Addendum One

April 24, 2013

Project Name & Number: RE BID East Energy Chiller I - Cooling Tower Addition/H27-1969
 Pre Bid Date & Time: April 16, 2013 @ 9am

MEZZANINE LEVEL PLAN

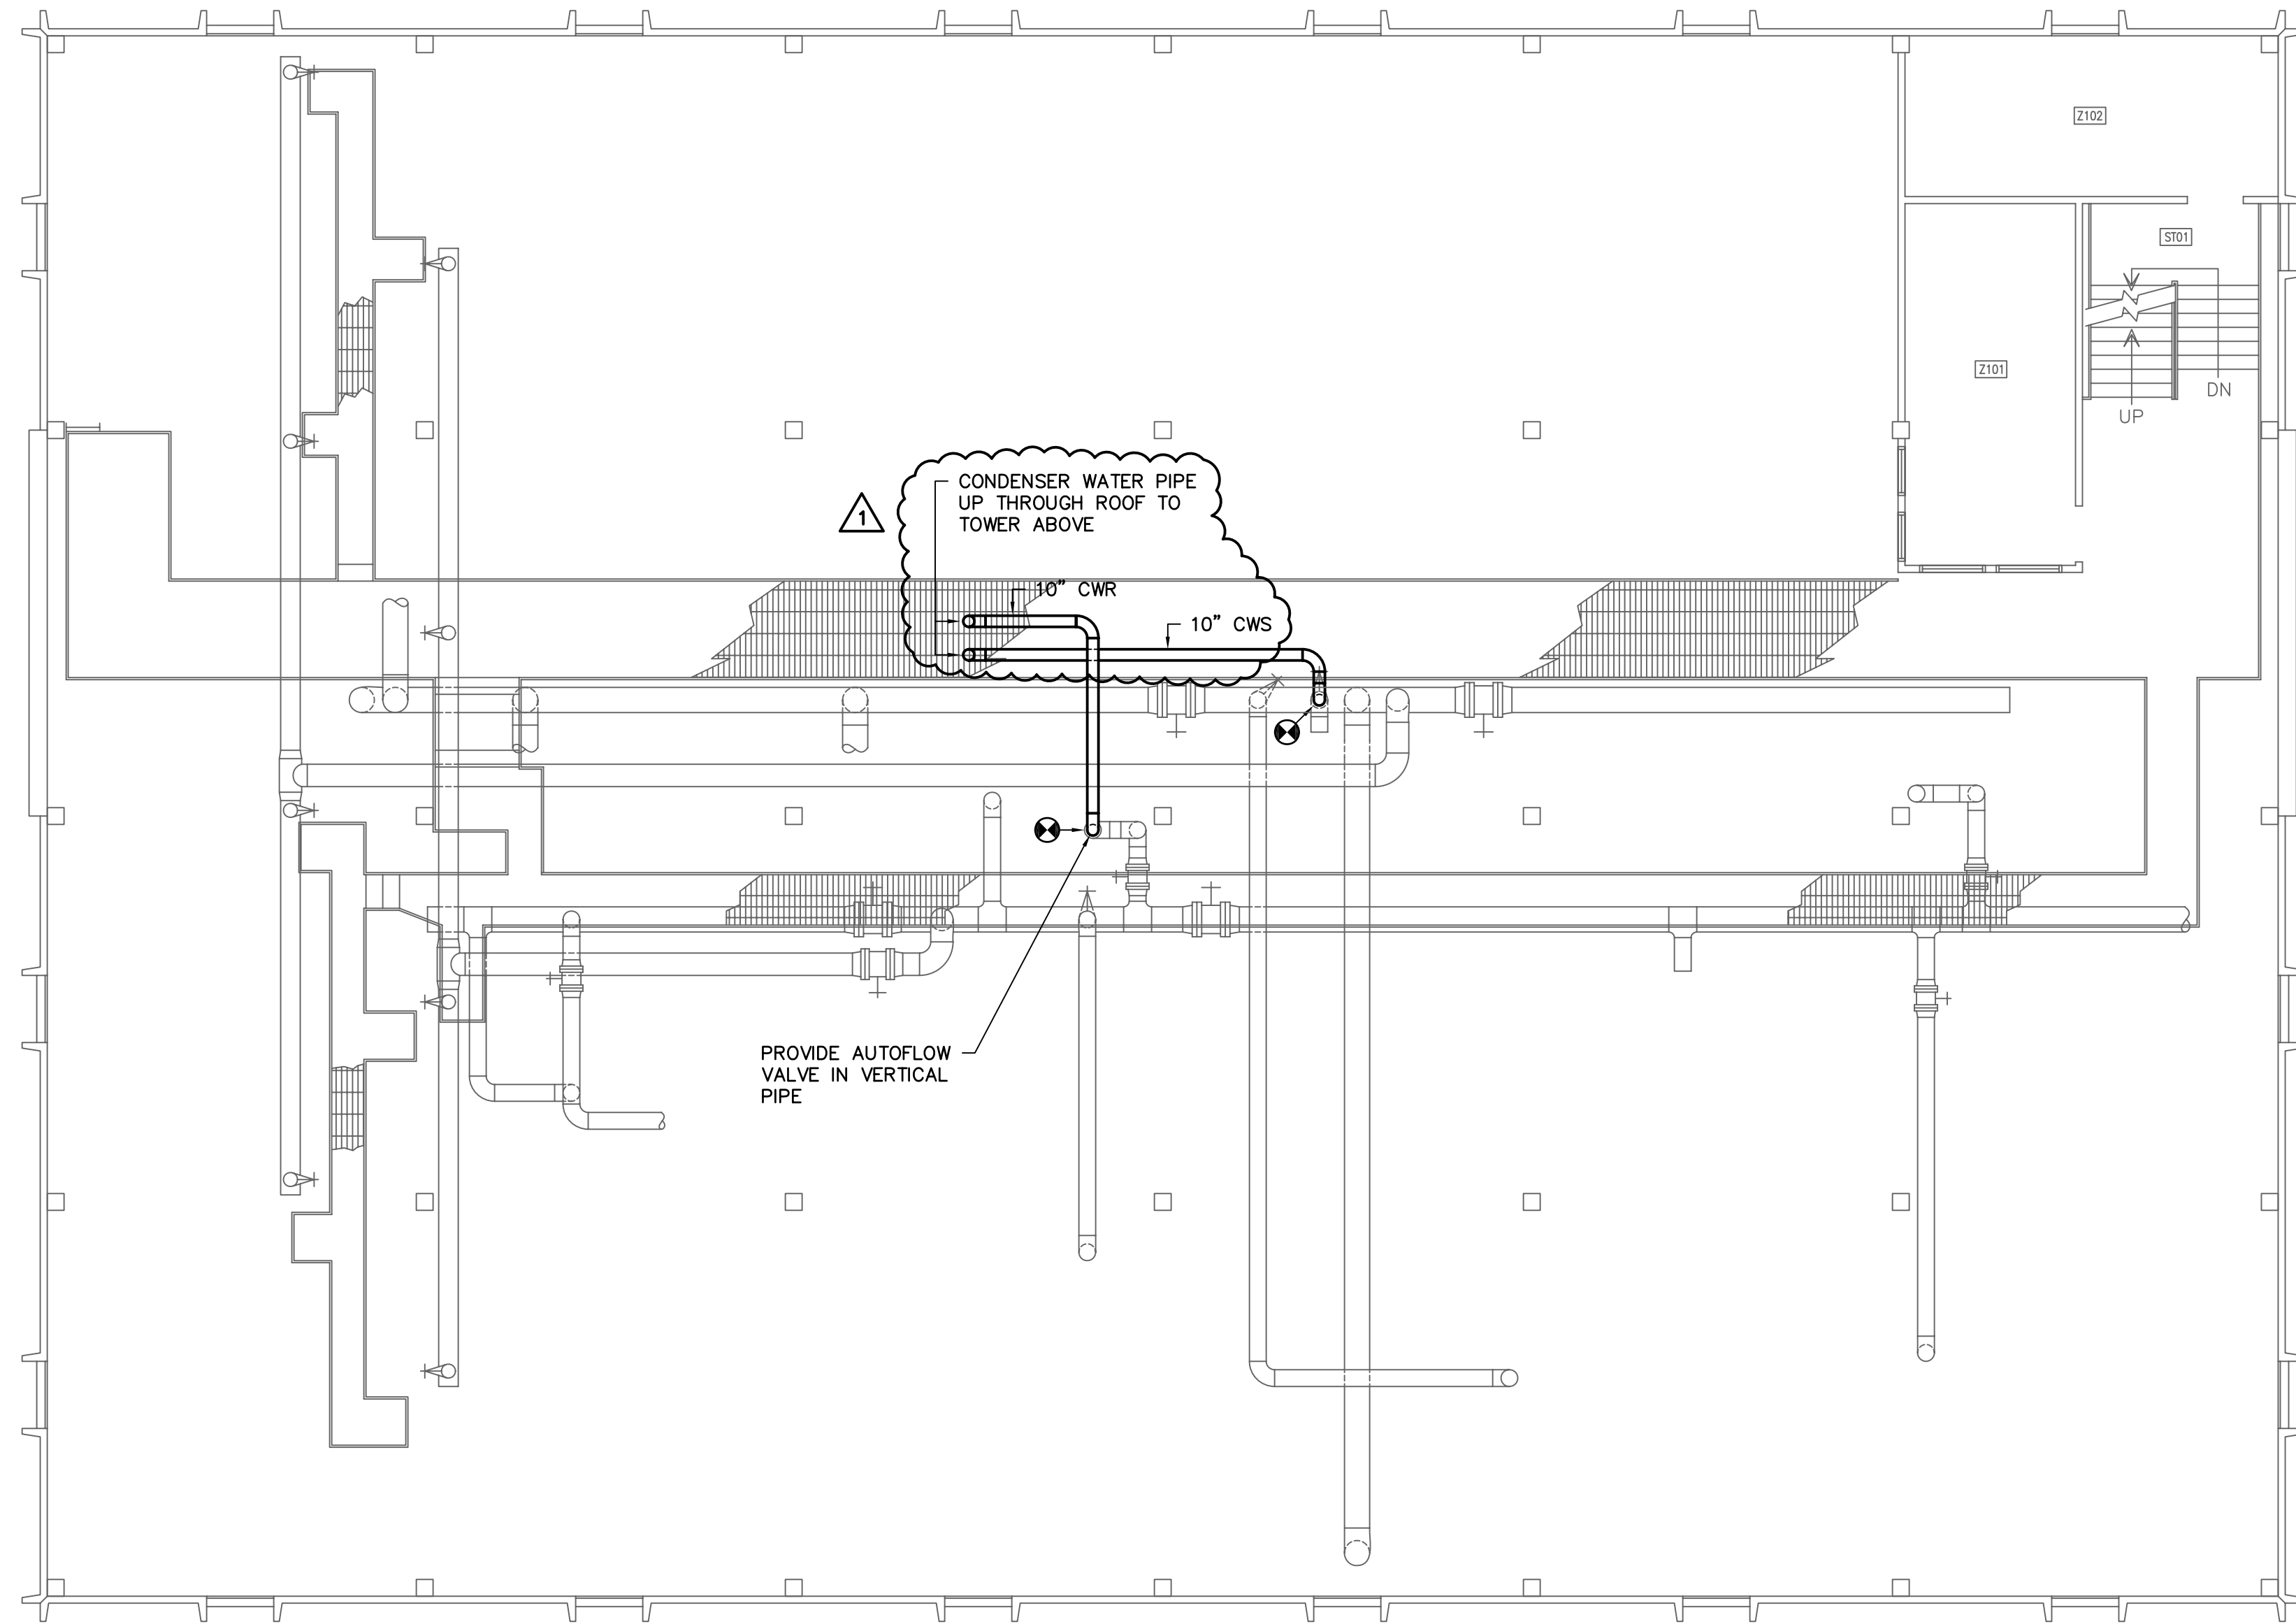
| 13. | <u>Revision:</u> Reference Drawing M-1, Mezzanine Level Plan. This plan shows relocating the water pipe penetration to the existing roof curb. |

1 ROOF PLAN
 M-2 SCALE: 1/8" = 1'-0"

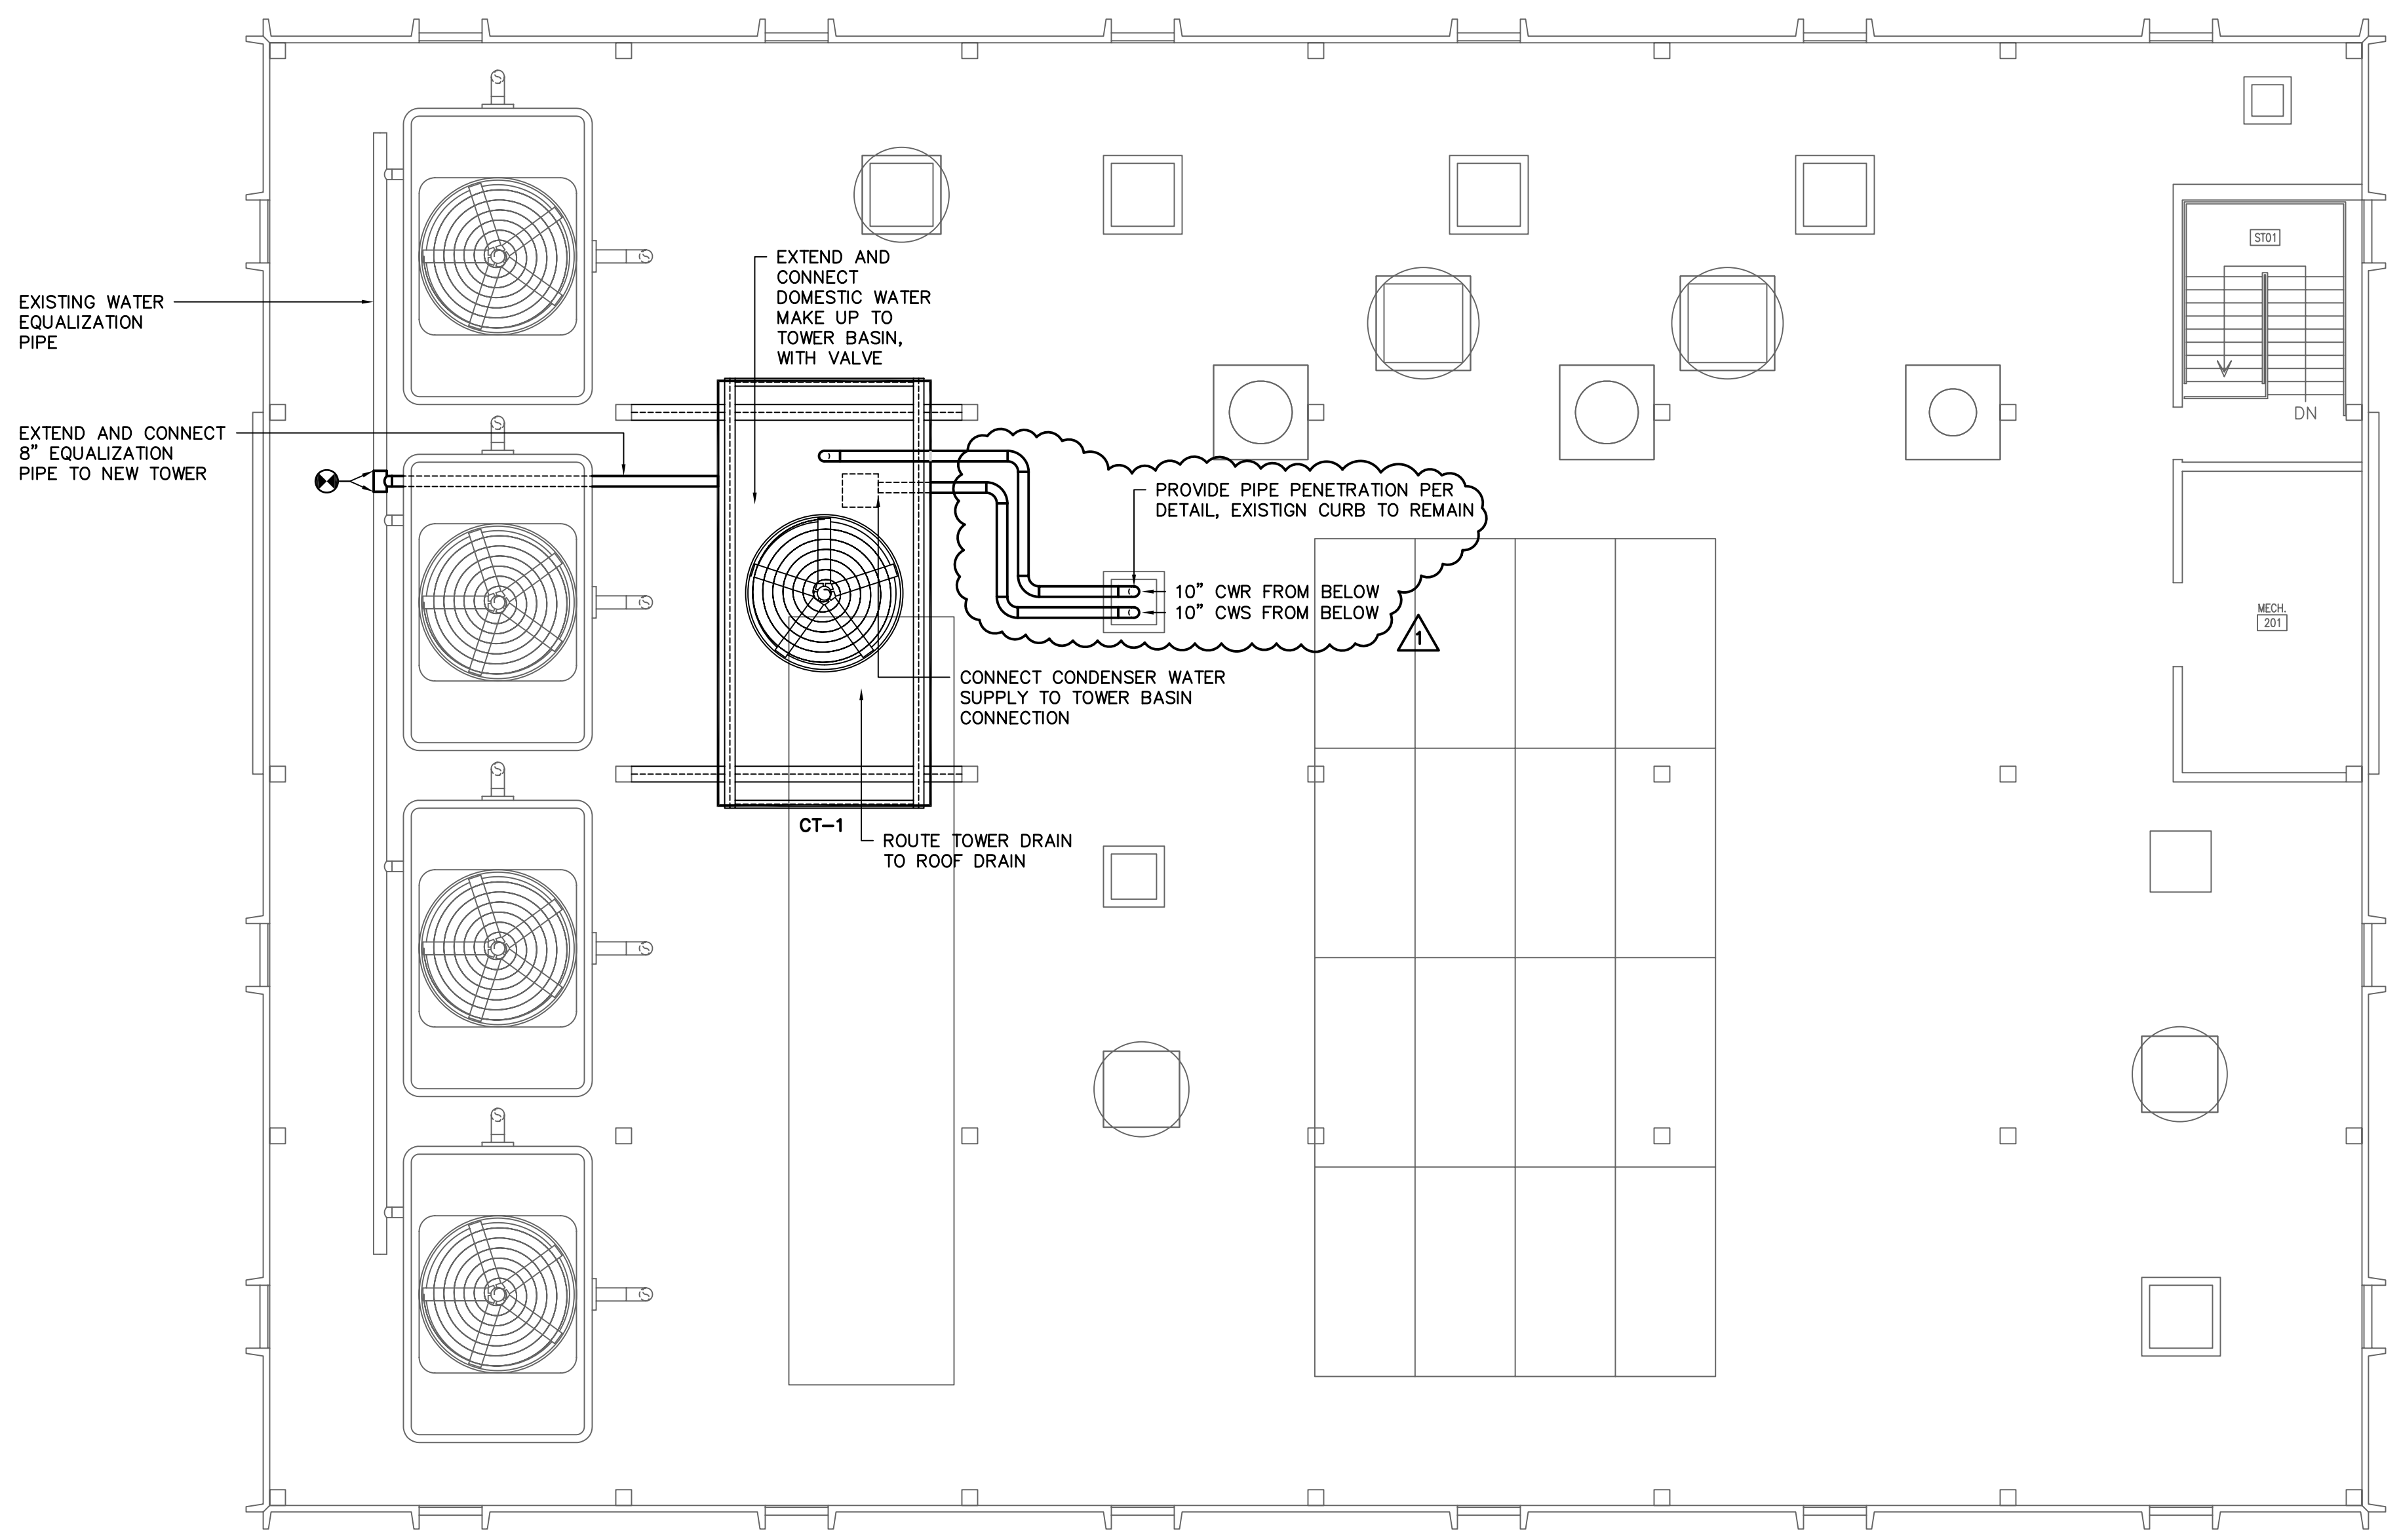
| 14. | <u>Revision:</u> Reference Drawing M-2, Roof Plan. This plan shows relocating the water pipe penetration to the existing roof curb. |

SHEET: M-3
OF 3
SHEET IN SET:

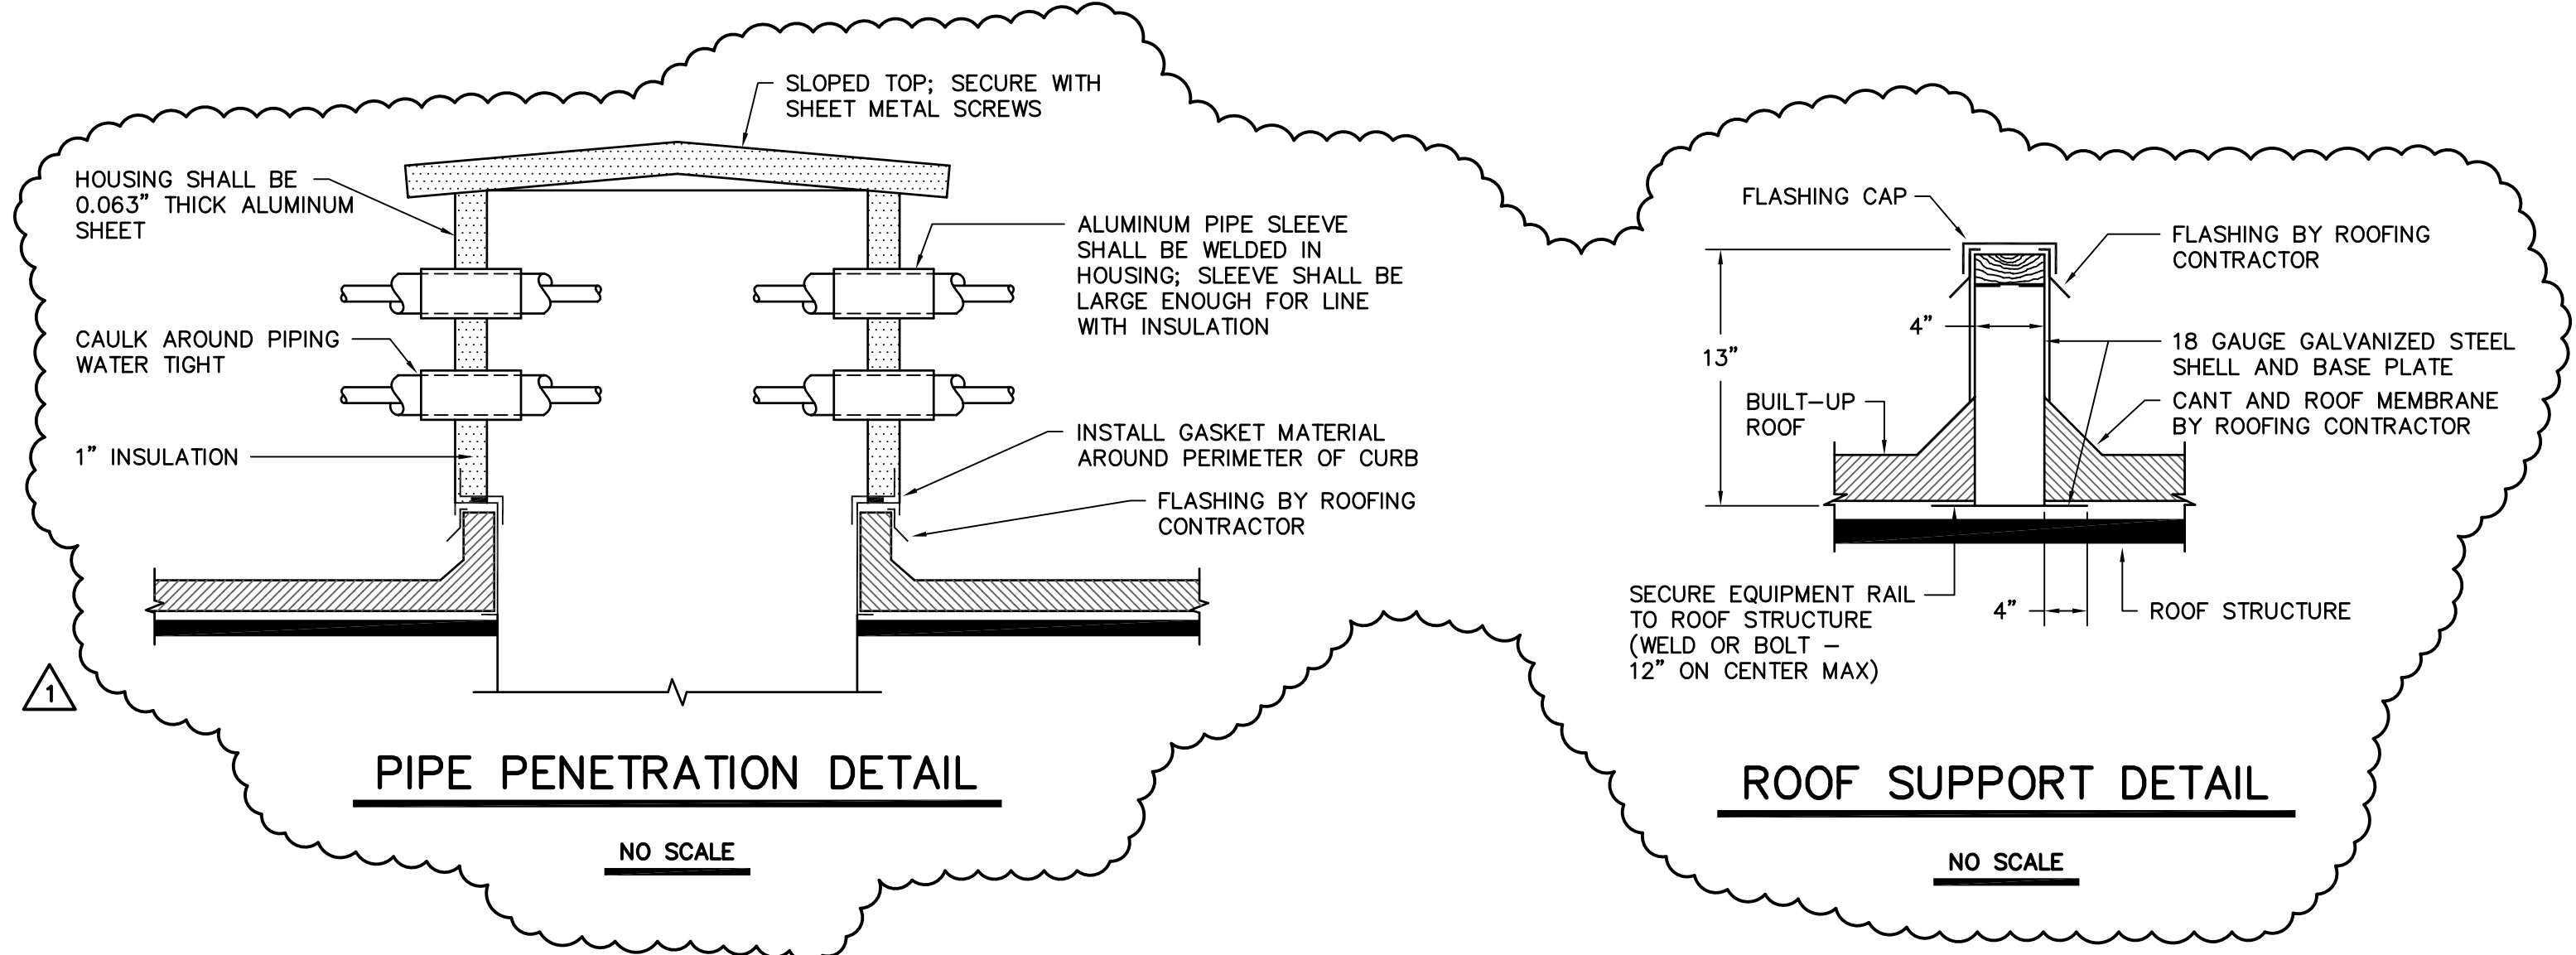
| 15. | <u>Revision:</u> Reference Drawing M-3, Roof Plan. This plan shows two details for the roof penetration at the existing curb and a pipe support rail on the roof. |
